**PREVOST**

**SAFETY  
RECALL**

**SR22-05B**

DATE :	September 2022	SECTION :	06 ELECTRICAL
SUBJECT:	ALTERNATOR BELTS REPLACEMENT

**Aramid reinforced cord belt (left) vs new polyester cord belt (right).**

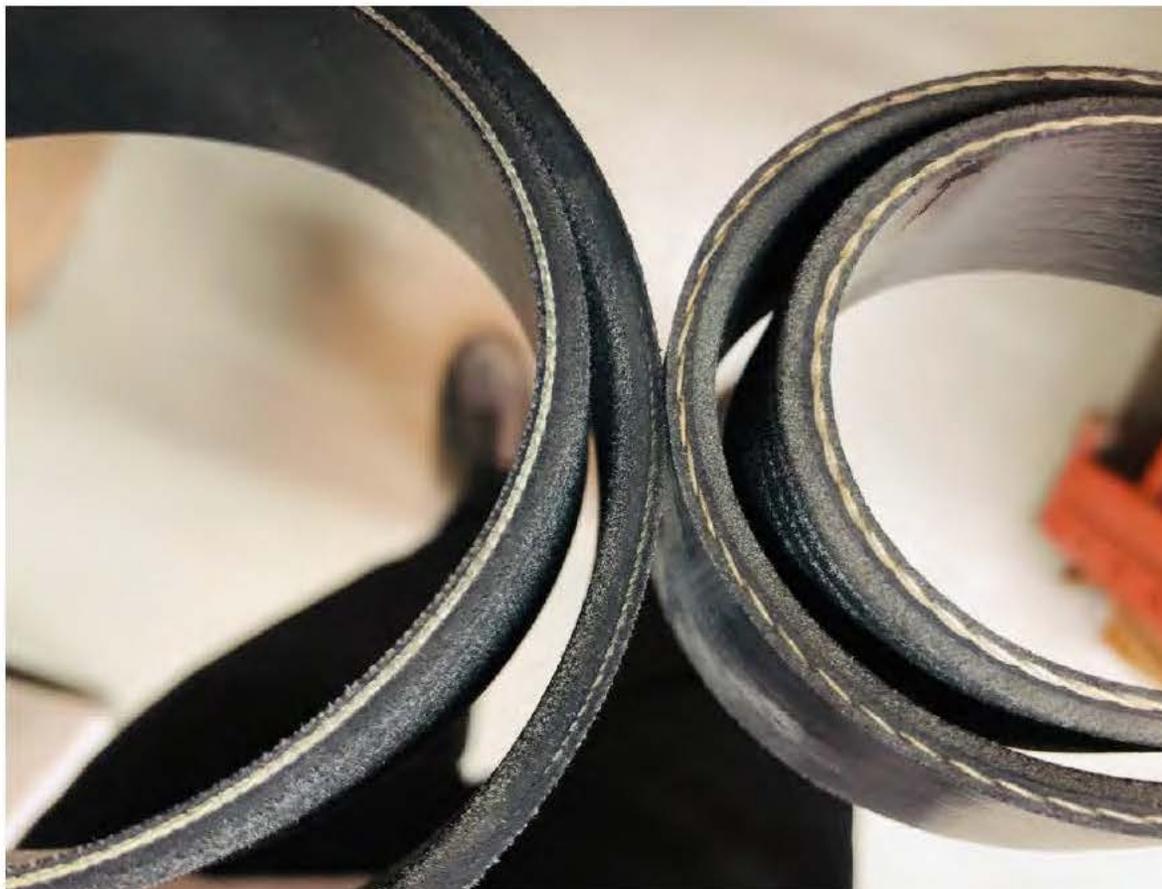
On vehicles affected by this recall, the heavy duty alternator belt (with aramid cord reinforcement) may continue to turn the alternator pulley after an alternator bearing failure. If the pulley continues to turn, it could lead to front bearing overheating.

Therefore, the heavy duty aramid belts must be replaced by polyester belts as needed following the interchange table provided.

7. Inspect the alternator belt(s) (refer to the picture above).
  - If the belts are polyester reinforced reinstall them.
  - If the belts are reinforced with aramid cords, complete the inspection and replace them with new polyester belts (see interchange table).
8. Reverse the procedure to reinstall the other belts on the vehicle.
